UNITED STATES PATENT AND TRADEMARK OFFICE

10/581,218

Office Action Summary	Application No. 10/581,218	Applicant(s) HOUBOLT ET AL.	
	Examiner Jason Daniel Prone	Art Unit 3724

DETAILED ACTION

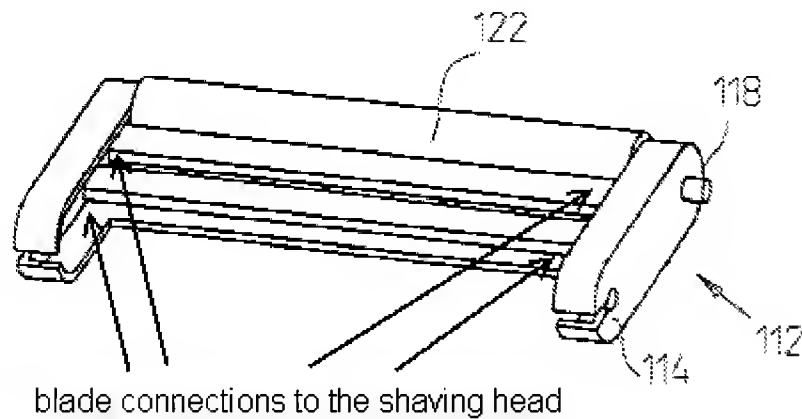
However, Avidor, as written above, discloses a force is distributed to the stretching device and the guard but Avidor fails to disclose the force is distributed equally to the stretching device and the guard.

Apprille Jr. teaches it is old and well known in the art of pivoting razor heads to balance out the force distribution based on the position of the pivot axis (column 2 lines

32-36 and column 7 lines 48-65). In light of Apprille Jr., it would have been well within one technical grasp to have balance out any two working portions designed to interact with the skin. In other words, it would have been obvious in Avidor to have moved the pivot axis 132 to a spot on the back of the razor to allow the forces to distribute equally to 104 and 122. Now the combination of Avidor in view of Apprille Jr. discloses the blades being substantially in-line with the first coupling (there is a straight line from the first blade to the coupling and there is a straight line from the second blade to the coupling) that is offset from the cutting edges (132). It would have been obvious to one having ordinary skill in the art at the time the invention was made to have distributed forces equally to the stretching device and the guard, because it has been held that where the general conditions of a claim are disclosed in the prior art, discovering the optimum or workable ranges involves only routine skill in the art and it has been held that discovering an optimum value of a result effective variable involves only routine skill in the art. Therefore, it would have been an obvious matter of design choice to modify the device of Avidor to obtain the invention as specified in claim 1. The claim would have been obvious because a person of ordinary skill has good reason to pursue the known options within technical grasp. If this leads to the anticipated success, it is likely the product is not of innovation but of ordinary skill and common sense.

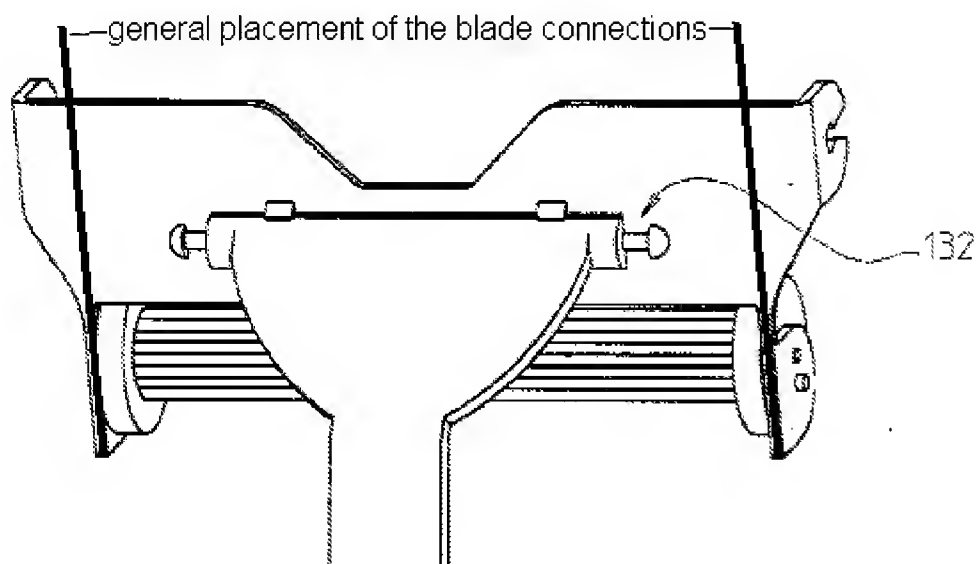
coupling and pivot axis is arranged between (see Figures below) and substantially in-line (there is a straight line from the first blade to the coupling and there is a straight line from the second blade to the coupling, therefore the coupling is in-line with each of the blades) with where the two cutting blades are coupled to the shaving head.

The blades are coupled to the outer edges of the shaving head.

The added dark lines represent roughly where these blade couplings are located to illustrate the pivot axis 132 is clearly between the where the two blades are coupled to the shaving head.

8. Applicant's arguments filed 21 September 2010 have been fully considered but they are not persuasive. First, portion 112 of Avidor's Figure 16 is considered part of the shaving head. With regards to claim 1, the blades are clearly coupled on either side of the shaving head to walls 114 (shown in the Figure above). With regards to claims 1 and 19, in light of the fact that there is a straight line between any two points, an imaginary straight line can be drawn to connect any one of the blade/head coupling locations with the pivot axis/coupling. Therefore, each of these blade/head coupling locations is in-line with the pivot axis/coupling at any given time.
